Re: *PJM Interconnection, L.L.C.*, Docket No. ER17-75-00_
Substitute Second Revised Service Agreement No. 3837

**Substitute Lackawanna ISA,
Substitute Second Revised Service Agreement No. 3837
(Marked)**

SINGLE-LINE DIAGRAM

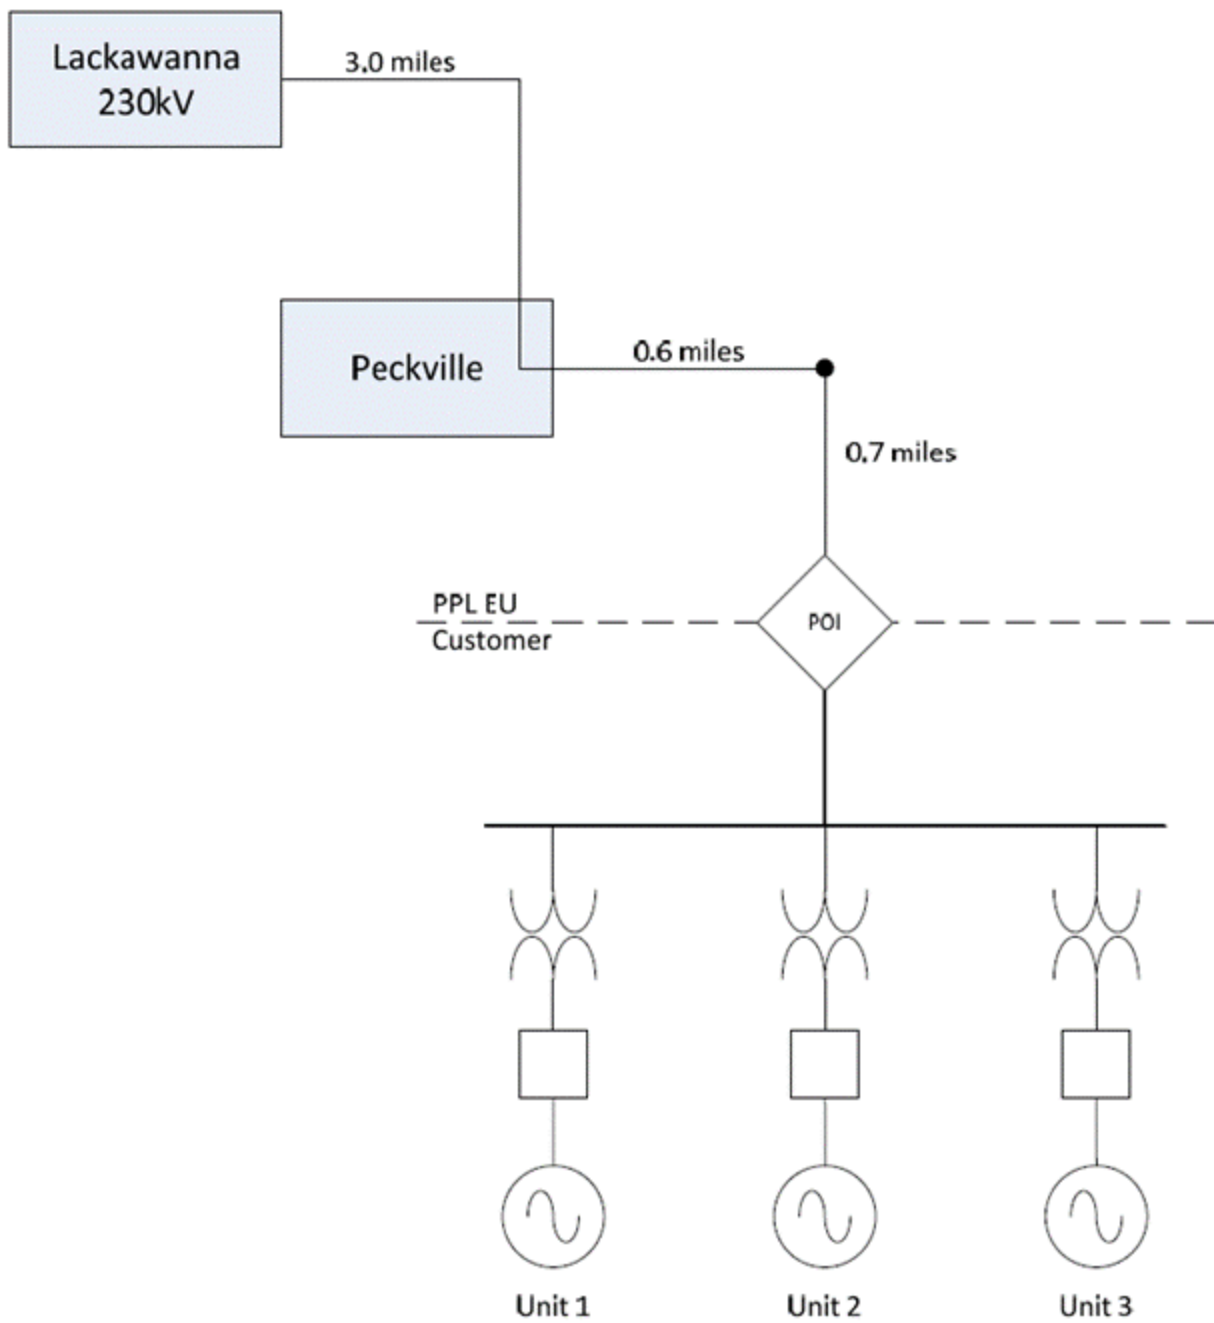
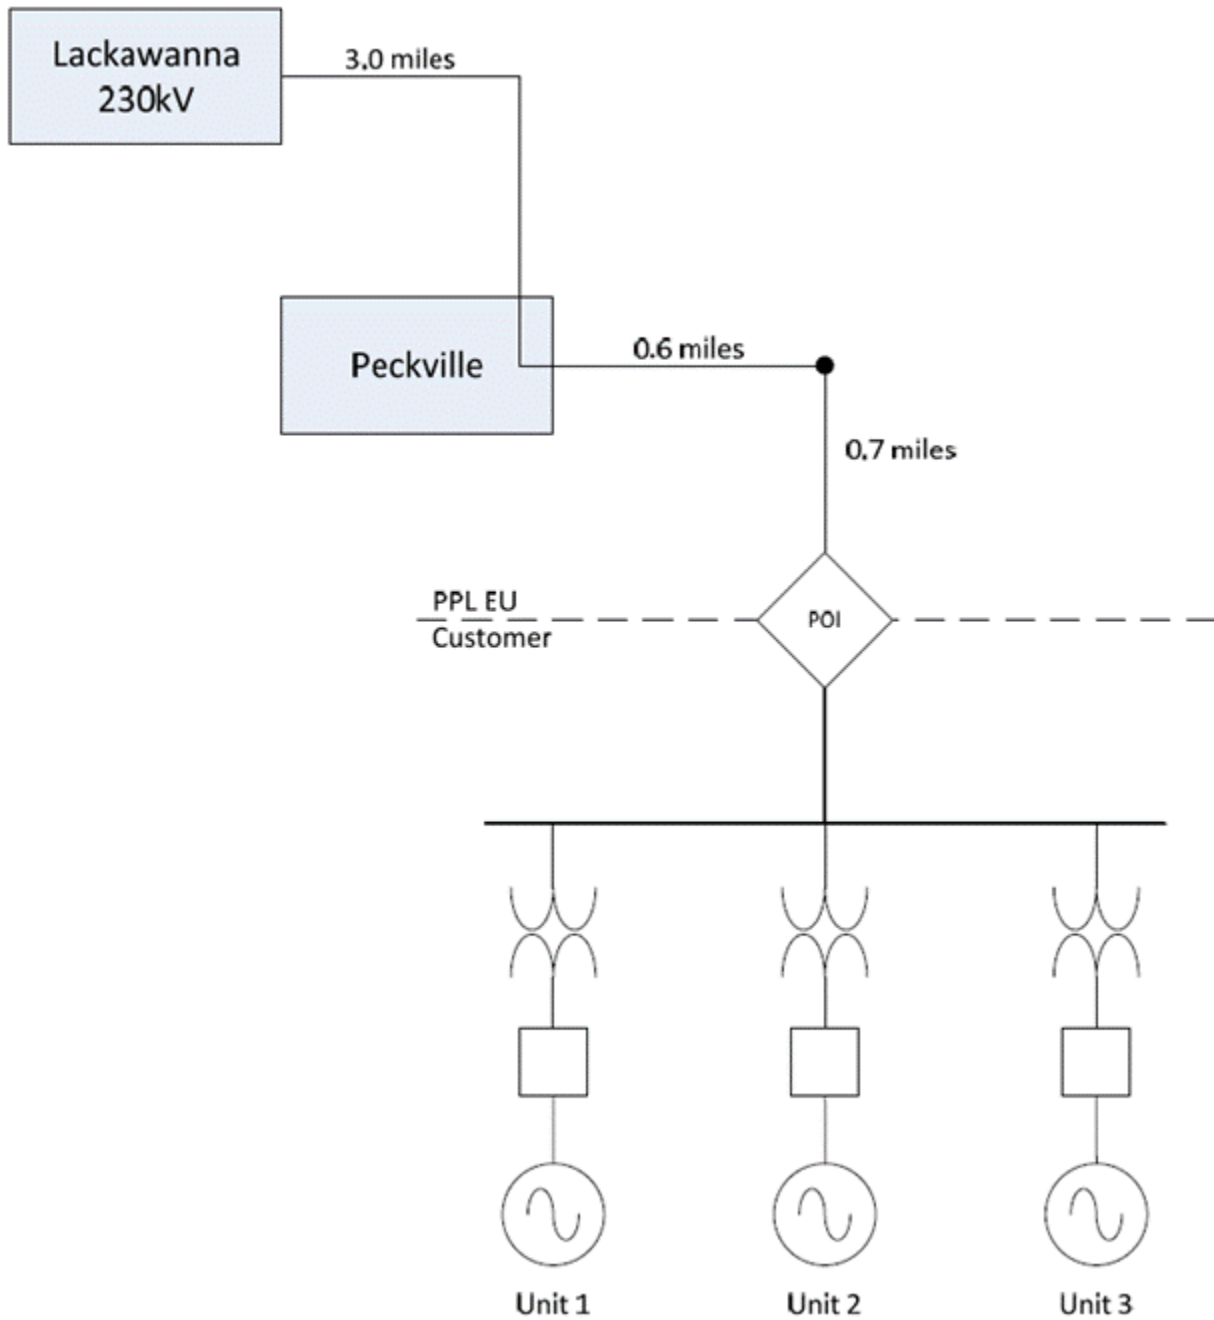
- Section 3.0.a(1) of the Specifications is revised to include three, rather than four, generator step up transformers and circuit breakers that Lackawanna is responsible to construct.

Tenth, the single-line diagram in Schedule B is revised to reflect the increase to the Customer Facility pursuant to the interconnection request associated with the Substitute Lackawanna ISA.
